NL-15-0699

Joseph M. Farley Nuclear Plant Unit 1  
Completion of Required Action by NRC Order EA-12-051  
Reliable Spent Fuel Pool Level Instrumentation

NRC Requests for Information

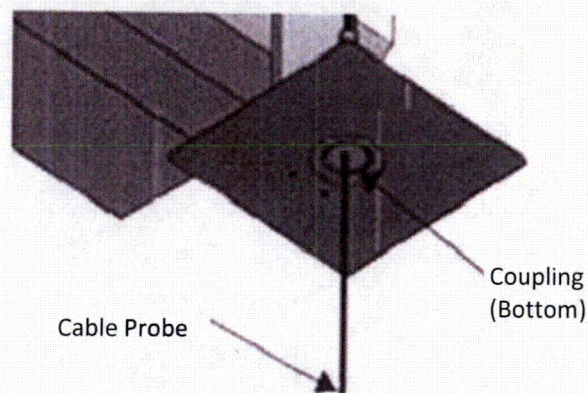
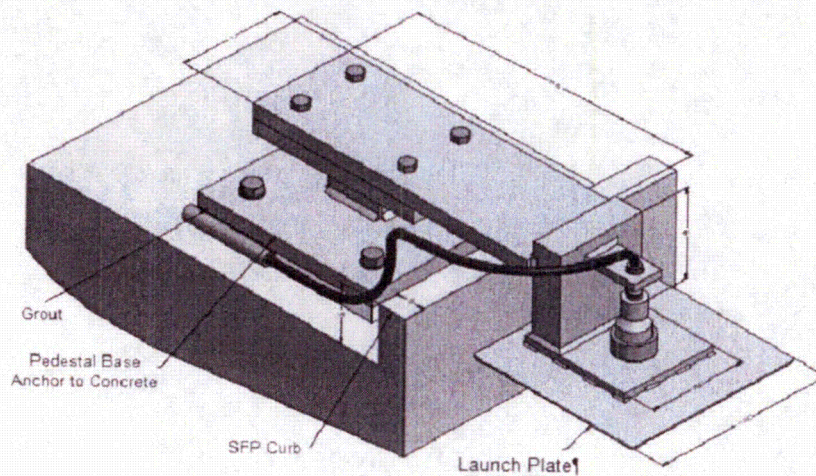
- b) A description of the manner in which the level sensor (and stilling well, if appropriate) will be attached to the refueling floor and/or other support structures for each planned point of attachment of the probe assembly. Indicate in a schematic the portions of the level sensor that will serve as points of attachment for mechanical/mounting or electrical connections.

- b) The mounting bracket is attached to the SFP concrete floor utilizing expansion-type concrete anchor bolts. The level sensor consists of a stranded stainless steel cable level probe that is threaded on the top end. The probe attaches (threads) into a coupling that is secured to the mounting bracket launch plate and extends down into the pool. The attachment to the signal cable is via a coaxial connection on the top side of the launch plate coupling.

The simplified drawing below shows a representation of the attachment of the probe and the sensor cable to the mounting bracket (launch plate), and mounting bracket attachment to the SFP structure. The Farley SFP does not have a raised concrete curb and as such, the mounting bracket does not utilize the curb for support.

Figure 1

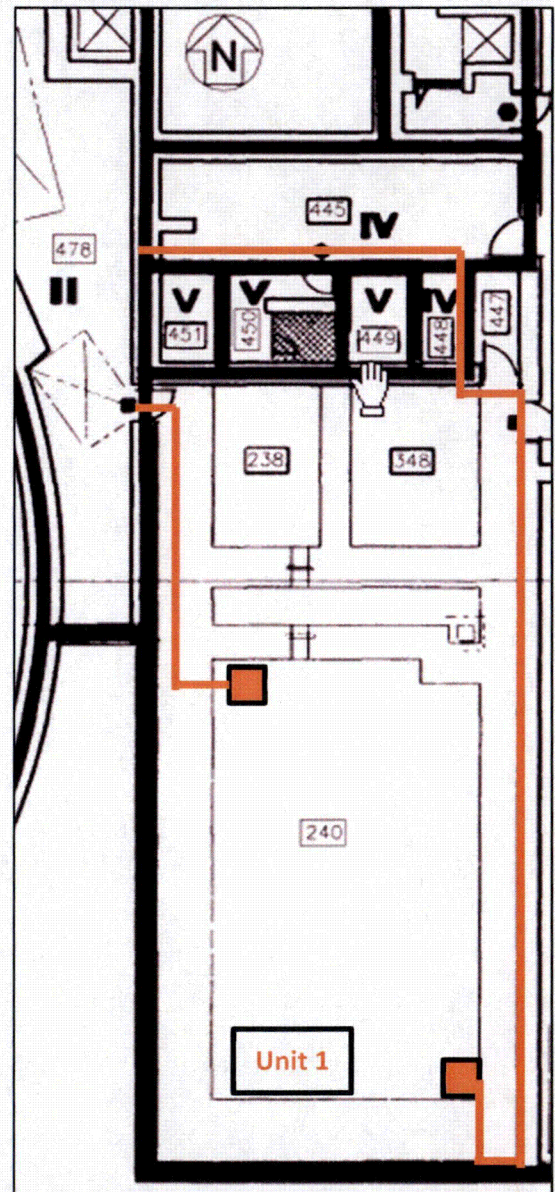
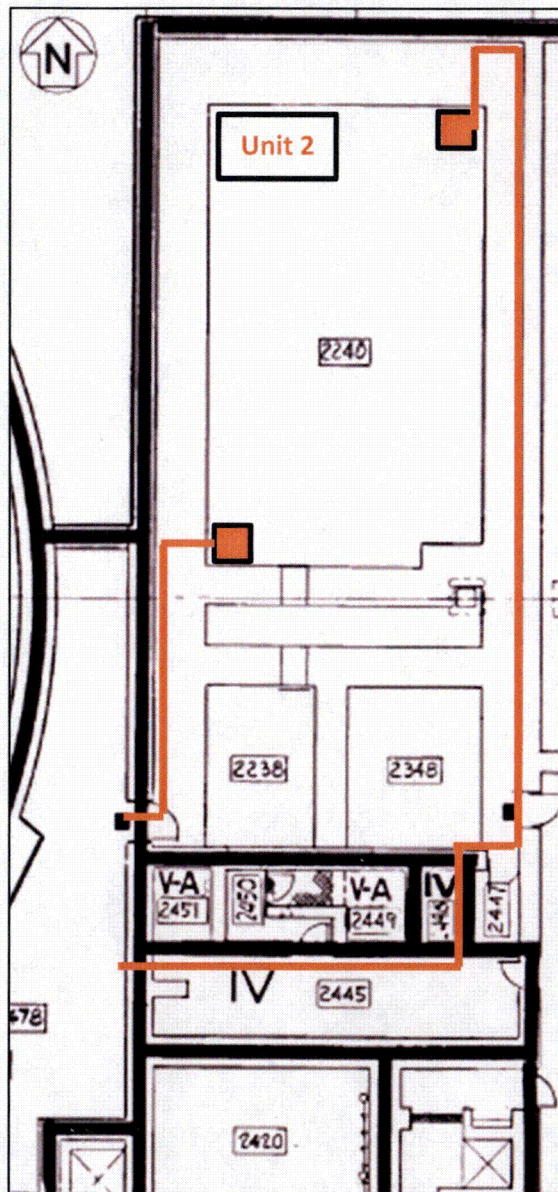
Please provide a clearly labeled sketch or marked-up plant drawing of the plan view of the SFP area, depicting the SFP inside dimensions, the planned locations/placement of the primary and back-up SFP level sensor, and the proposed routing of the cables that will extend from these sensors toward the location of the read-out/display device.

A plan view sketch of the SFP area is provided as Figure 1. The sketch depicts the SFP inside dimensions, locations/placement of the primary and alternate level sensors, and the routing of cables that extend toward the location of the electronics. Physical separation of the primary and alternate channels, to the extent practicable and comparable to the short side of the pool, is used to provide reasonable protection of the level indication function against missiles that may result from the damage to the structure over the SFP.

Figure 2

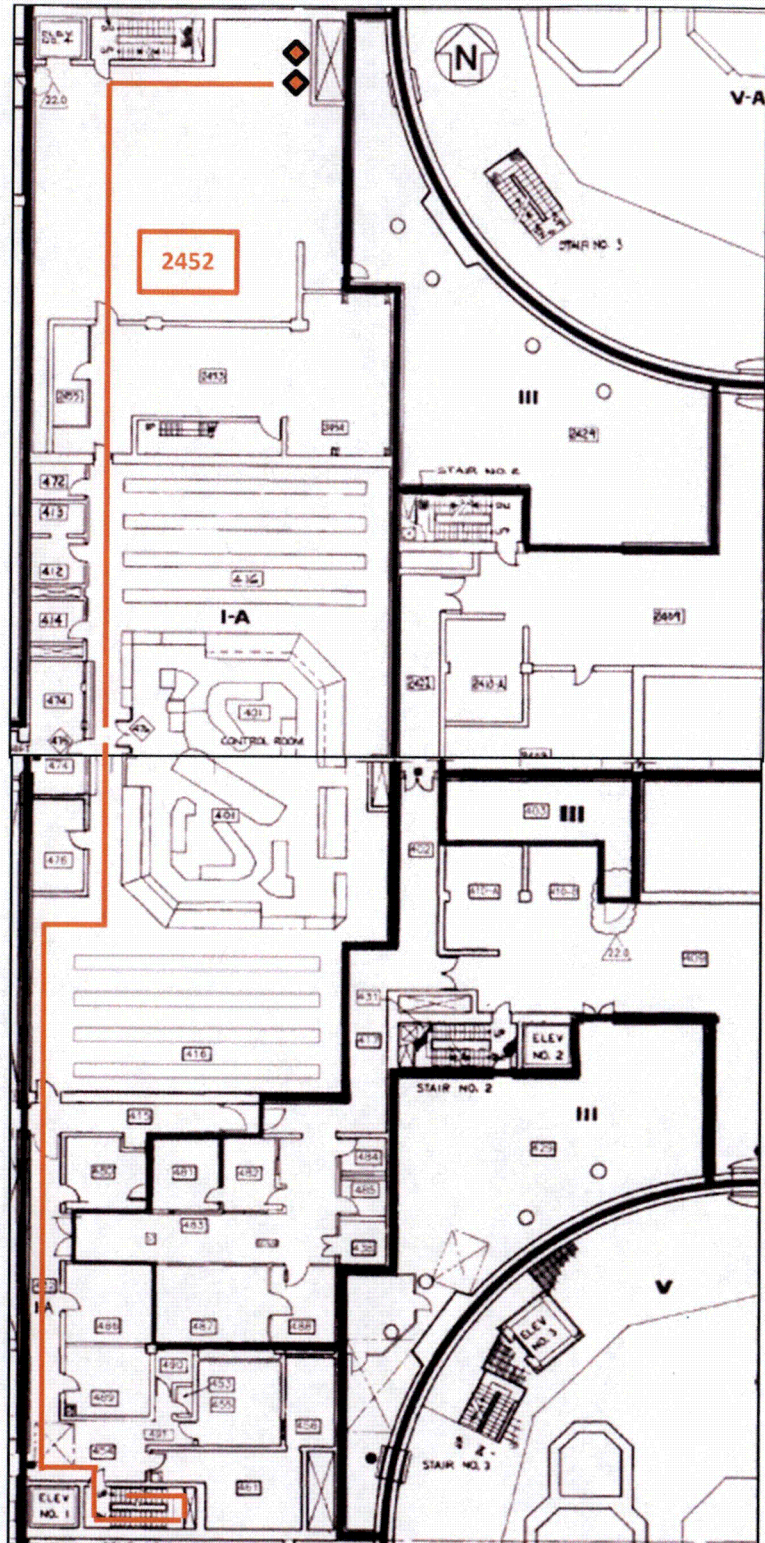
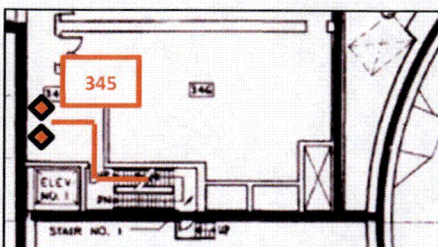
- a) The specific location for the primary and backup instrument channel displays.
- b) For any SFP level instrumentation displays located outside the main control room, please describe the evaluation used to validate that the display location can be accessed without unreasonable delay following a BDB event. Include the time available for personnel to access the display as credited in the evaluation, as well as the actual time (e.g., based on walk-throughs) that it will take for personnel to access the display. Additionally, please include a description of the radiological and environmental conditions on the paths personnel might take. Describe whether the display location remains habitable for radiological, heat and humidity, and other environmental conditions following a BDB event. Describe whether personnel are continuously stationed at the display or monitor the display periodically.

- a) See Figure 2 for SFPLIS equipment proposed location sketches.

The proposed location of the U1 and U2 Primary display panels is in room 2452 on EL 155' of the Aux Building. The proposed location of the U1 and U2 Alternate display panels is in room 345 on EL 139' of the Aux Building.
- b) The locations have been evaluated within the DCP considering the accident conditions described in NEI 12-02 and NEI 12-06, using design inputs from Westinghouse, existing Station Blackout evaluations and NUMARC-8700, "Guidelines and Technical Bases for NUMARC Initiatives Addressing Station Blackout at Light Water Reactors", November 20, 1987. The results of the evaluation performed, to determine accessibility of the SFPLI displays following an ELAP event, indicate the displays can be accessed without unreasonable delay and without placing station personnel at undue risk with regards to temperature, humidity, and radiation levels.

The selected location of the U1 and U2 Primary display panels in room 2452 on EL 155' of the Aux Building is approximately 180 feet from the West exit of the Control Room. The selected location of the U1 and U2 Alternate display panels in room 345 on EL 139' of the Aux Building is approximately 220 feet from the West exit of the Control Room. Using a conservative walking pace of 1 mph, Primary & Alternate display locations would each require less than 10 minutes to access the display location, perform local function and return to the Control Room. With the displays located outside the Radiation Controlled Area, the substantial structures between the SFP and the pathway to the display,
